RESOURCE CONSENT INSPECTION

Site Address: 1334 Sandspit Road, Warkworth

Consent Number(s): L41252

RESOURCE CONSENT – COMPLIANCE INSPECTION

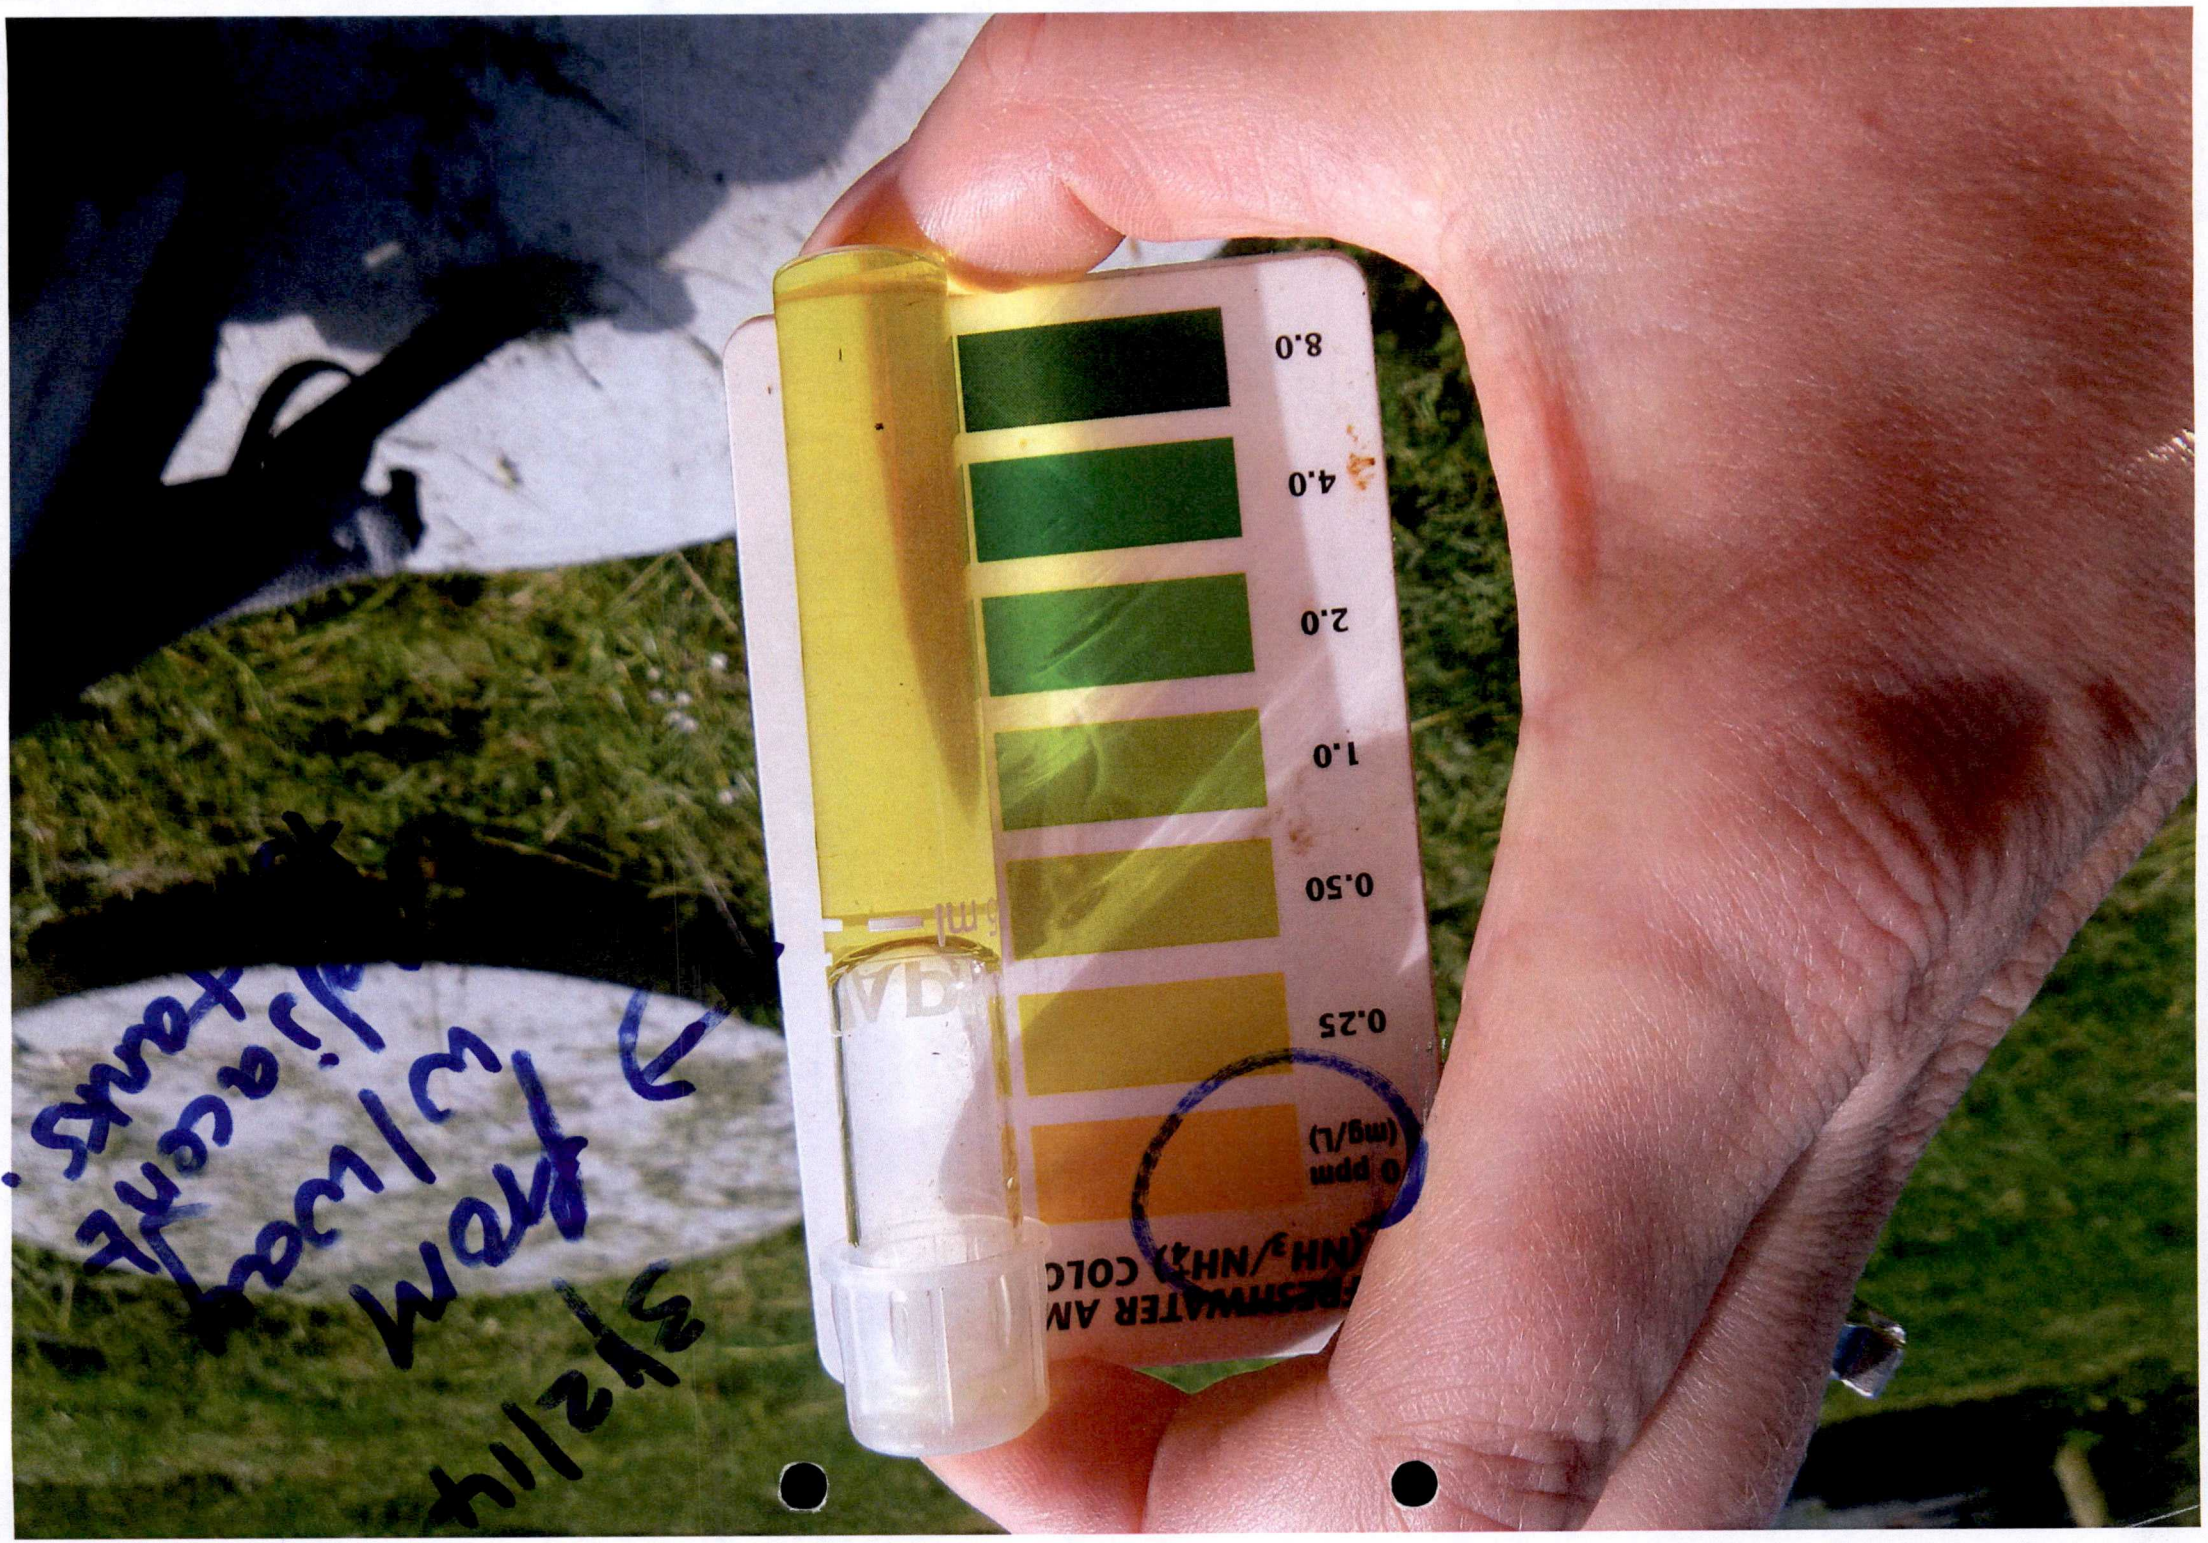
*- Asbuilt Plans saved
on consents file. (large
size).*

(Need flows = check next inspection)
